Southern California Edison Company INTERIM CALCULATION CHANGE NOTICE (ICCN)/ CALCULATION CHANGE NOTICE (CCN) COVER PAGE	CALC. NO. M-0050-017		ICCN NO./ PRELIM. CCN NO. N-3	PAGE 1	TOTAL NO. OF PAGES 24
	BASE CALC. REV. 2	UNIT 2&3	CCN CONVERSION : CCN NO. CCN- 3	CALC. REV. 2	
	CALCULATION SUBJECT : BTP RSB 5-1 Condensate Inventory				
CALCULATION CROSS-INDEX ☐ New/Updated index included ☒ Existing index is complete		ENGINEERING SYSTEM NUMBER / PRIMARY STATION SYSTEM DESIGNATOR 1305 / ADA		Q-CLASS II	
CONTROLLED PROGRAM OR DATABASE ACCORDING TO SO123-XXIV-5.1		PROGRAM / DATABASE NAME (S)		VERSION/RELEASE NO.(S)	
Site Programs/Procedure Impact? ☐ NO ☒ YES, AR No. AR960201089		☐ PROGRAM ☐ DATA BASE ☐ ALSO, LISTED BELOW

REVISE pages 10, 11, 12, 18, 20, 36, 37, 38, 39, 40, 42, 43, 47, 50, 63, 64, 68 and 87 of CCN N-2

due to the change of the isolation time for valve 2(3) -HV-5715 from 45 minutes to 90 minutes
and for the valve 2(3)-1414-MU-092 from 45 minutes to 30 minutes.

Subject BTP RSB 5-1 Condensate Inventory

FIG. 2-1: SCHEMATIC DIAGRAM OF VOLUMES AT CST T-120

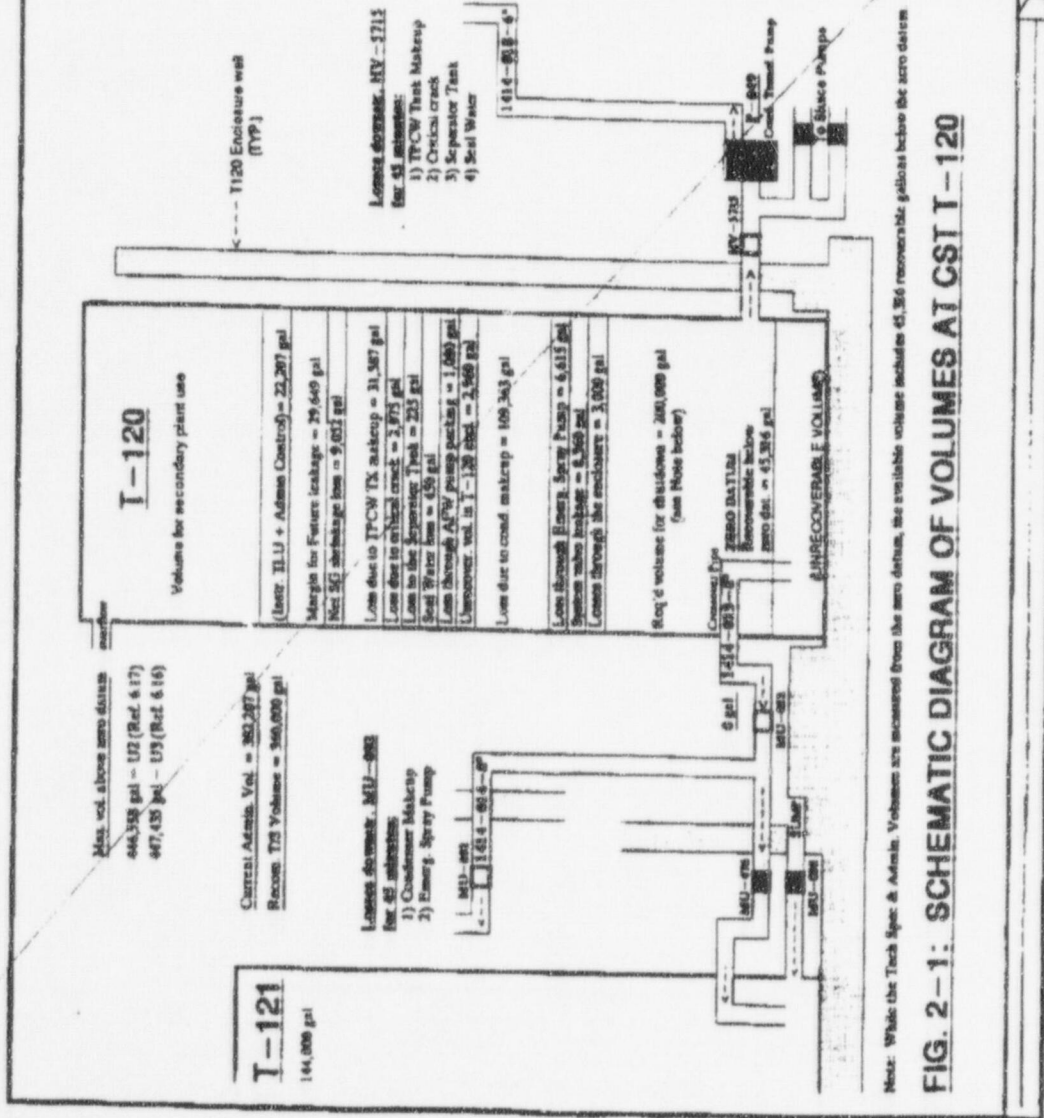
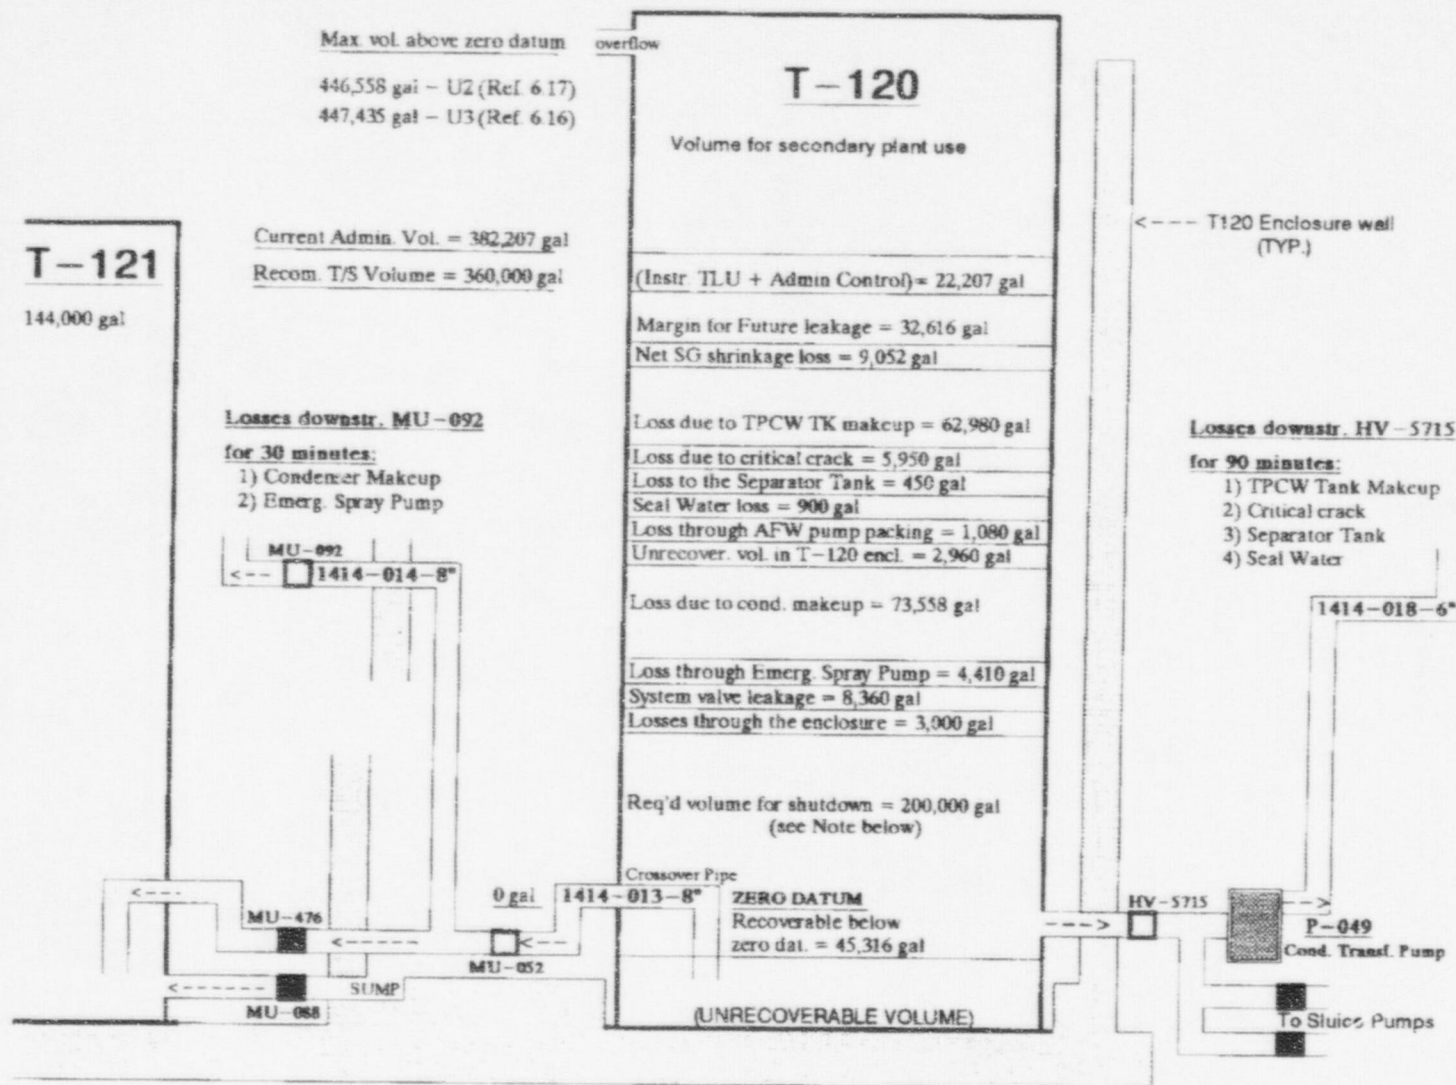
The minimum required volume in T-120 above the tank's zero datum is 330,351 gallons, assuming operator action within 45 minutes after a OBE to isolate S2/3-1414-MU-092 and 2/3-HV-5715. The recommended Technical Specification (T.S.) volume is 360,000 gallons, which includes 29,649 gallons of available margin that can be allocated as required should a future inventory concern occur. These results are detailed in the Table 2-1 on the following sheet and are graphically illustrated on a schematic diagram on Figure 2-1.

The minimum required volume in T-120 above the tank's zero datum is 327,384 gallons, assuming operator action within 30 minutes after a DBE to isolate S2(3)1414-MU-092 and 90 minutes after a DBE to isolate 2(3)HV-5715. The recommended Technical Specification (T.S.) volume is 360,000 gallons, which includes 32,616 gallons of available margin that can be allocated as required should a future inventory concern occur. These results are detailed in the Table 2-1 on the following sheet and are graphically illustrated on a schematic diagram on Figure 2-1.

Note: While the Tech Spec & Admin. Volumes are measured from the zero datum, the available volume includes 45,316 recoverable gallons below the zero datum.
